Subject: Gundy Road RFI response (DA/163/2017) - Biodiversity

In regard to the proposed development located at 150 Gundy Road, Scone (DA/163/2017), the Decision Review Panel of the Hunter & Central Coast Regional Planning Panel have issued a request for further information (RFI) which concern biodiversity and the Plan of Management for the drainage reserve. The specific requests and Kleinfelder's response to these comments are detailed below.

Plate 1: Subject Site (Green) and Proposed Nest box Installation Locations (Orange)

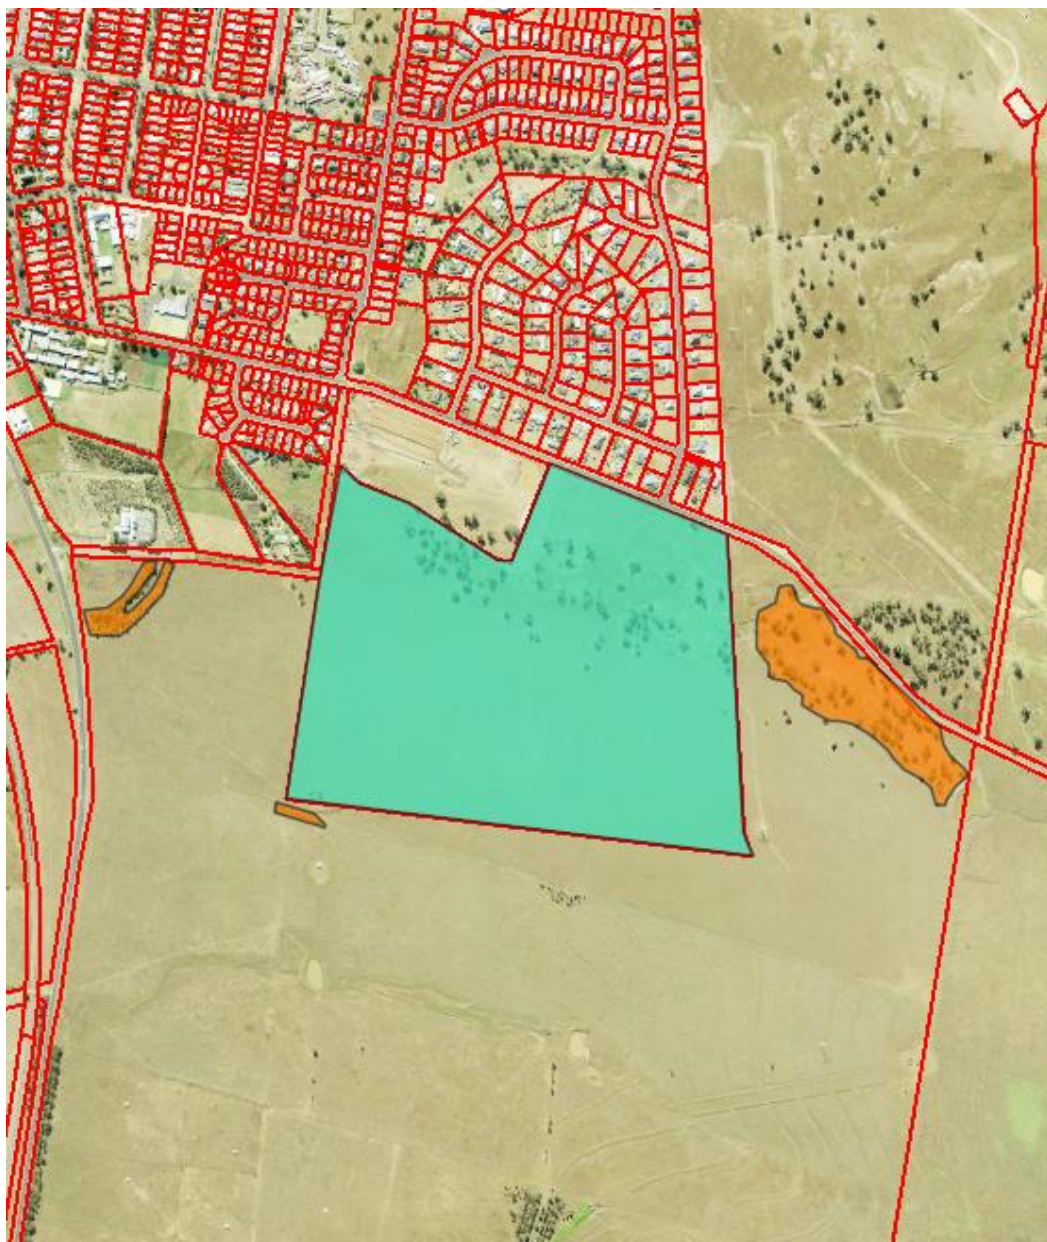
Biodiversity - It is noted in the Plan of Management (see below) that almost all trees within the drainage reserve already contain multiple hollows, nest boxes may need to be installed at an alternative site, in order to offset those hollows lost with the removal of hollow bearing trees in the "development area" of the subdivision. No alternative location for the nesting boxes is nominated or potential ways of housing nesting boxes with the drainage reserve. Please provide clarification on how this issue will be addressed.

It is noted that most trees within the proposed drainage reserve contain hollows and are unlikely to be suitable for nest box installation. Given the abundance of hollows within existing trees, there is no lack of nesting/roosting resources within the drainage reserve. **As such, nest boxes are proposed to be installed within vegetation to the direct north, south, and west of the proposed Development Site (under the same land ownership) (see Plate 1). Nest boxes will be installed in trees without pre-existing hollows.**
